Access Compliance Report

Public Rights-of-Way

(Curb Ramps)

Intersection ID: 43676	Main Street: SARDIS_COMMONS_LN	Cross Street: SARDIS_RD	Location: SW
ADA ID: 75F43041F433	Ramp Type: PerpDiag	Initial Pass/Fail: Fail	Overall Compliance: No
Severity Score: 33.75			
Codes/Mitigation Info/Possible Solution		Field Measurements/Component Compliance

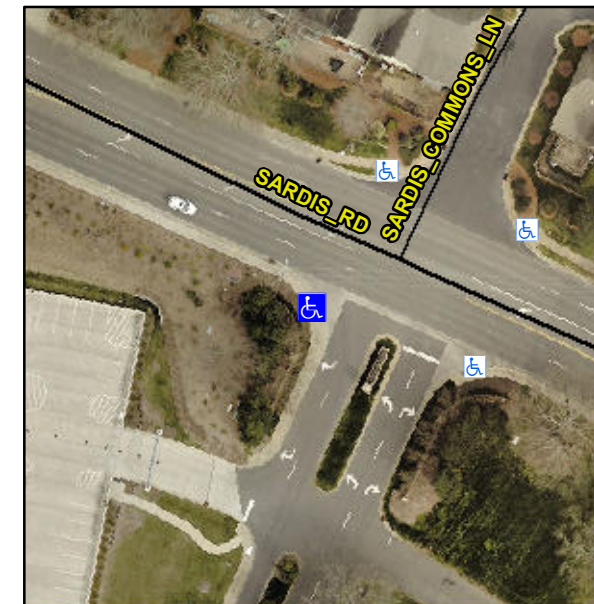
Not Found, R304.5.1, R304.5.3

Compliance	Description	Data	Compliance	Description	Data
N/A	Ramp Length (in)	60.0	Yes	Ramp Slope (%)	7.3
No	Ramp Width (in)	43.0	No	Ramp XSlope (%)	8.8
N/A	Flare Type LT	N/A	N/A	Flare Type RT	N/A
N/A	Flare Slope LT (%)	N/A	N/A	Flare Slope RT (%)	N/A
N/A	Flare Traversable LT?	N/A	N/A	Flare Traversable RT?	N/A
N/A	Landing Length (in)	N/A	N/A	DWS Provided?	N/A
N/A	Landing Width (in)	N/A	N/A	DWS Contrast?	N/A
N/A	Landing Slope (%)	N/A	N/A	DWS Length (in)	N/A
N/A	Landing X Slope (%)	N/A	N/A	DWS Full Width?	N/A
N/A	Landing Curb? (Y/N)	N/A	N/A	DWS Offset (in)	N/A
N/A	Shared Landing?	N/A			
N/A	Gutter Ponding?	N/A	N/A	Gutter Slope (%)	N/A
N/A	Gutter Lip Ht (in)	N/A	N/A	Gutter X Slope (%)	N/A
N/A	Painted X Walk1?	No	N/A	Painted X Walk2?	No
	X Walk 1 Direction	To SE		X Walk 2 Direction	To NE
N/A	X Walk 1 Width (in)	N/A	N/A	X Walk 2 Width (in)	N/A
	X Walk 1 Slope (%)	5.6		X Walk 2 Slope (%)	3.4
	X Walk 1 X Slope (%)	4.5		X Walk 2 X Slope (%)	7.2

N/A	Ramp inside XWalk1?	N/A	N/A	Ramp inside XWalk2?	N/A
	Road Slope (%)	7.4	N/A	Clear Space?	N/A
	Road X Slope (%)	2.7	N/A	Clear Space to XWalk (in)	N/A
N/A	Any Obstructions?	N/A	N/A	Storm Grate/Utility Hazard?	N/A
	Obstruction Type			Storm Grate/Utility Type	
		N/A			N/A
			Yes	Surface Condition? (G/P)	Good

Remove & Replace Curb Ramp With Two New Directional Ramps or Equivalent.
